UNITED STATES
DEPARTMENT OF THE INTERIOR
BUREAU OF LAND MANAGEMENT

SUBMIT IN TRIPLICATE - Other instructions on page 28. Well Name and No.
SANTA FE FED 4

RKI EXPLORATION & PRODUCTION, LLC RESPECTFULLY REQUESTS TO P&A THE ABOVE MENTIONED WELL. THE WBD AND PROCESS IS ATTACHED.

Santa Fe Fed #4
Plug and Abandon Procedure
East Herradura Bend Delaware Field

Santa Fe Fed #4
Proposed WBD

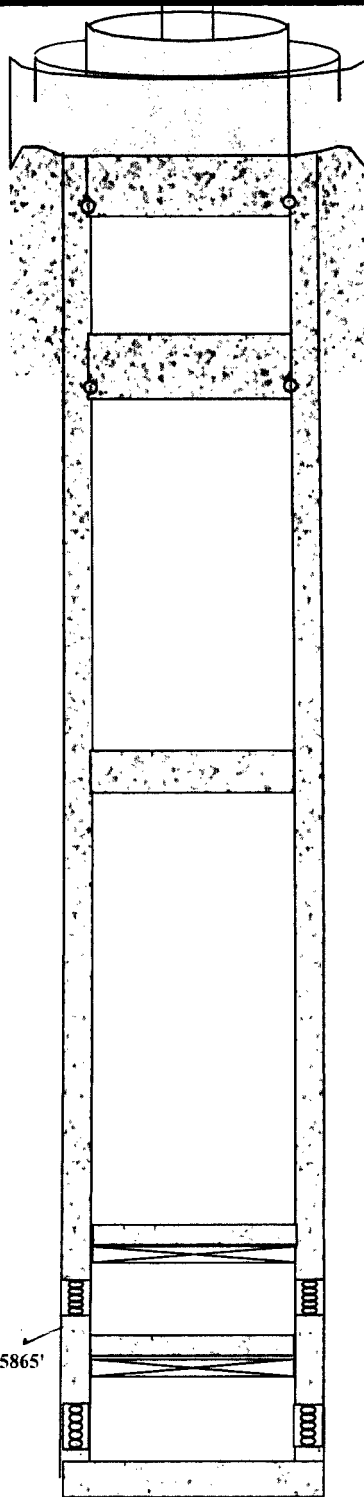
- 3) ND WH, NU 3K# BOP.
- 4) POOH rods & tbg. & Lay Dn.
- 5) MI RU wireline unit. Run 5 1/2" GR/JB to 5,511'.
- 6) RIH w- 5 1/2" tbg. conveyed CIBP & set @ 5,511' - PU 1 jt. Pump 135 bbls. heavy mud. Spot 25sx Class C Cement (14.8 ppg, 6.3 gps, 1.32 cfs yield) 5,511' - 5,311' & flush with heavy mud. TOOH w- tbg. *Add additional cmt to cover DVT @ 5124. cmt from 5511-5074. WOC Tag*

DVT @ 5124
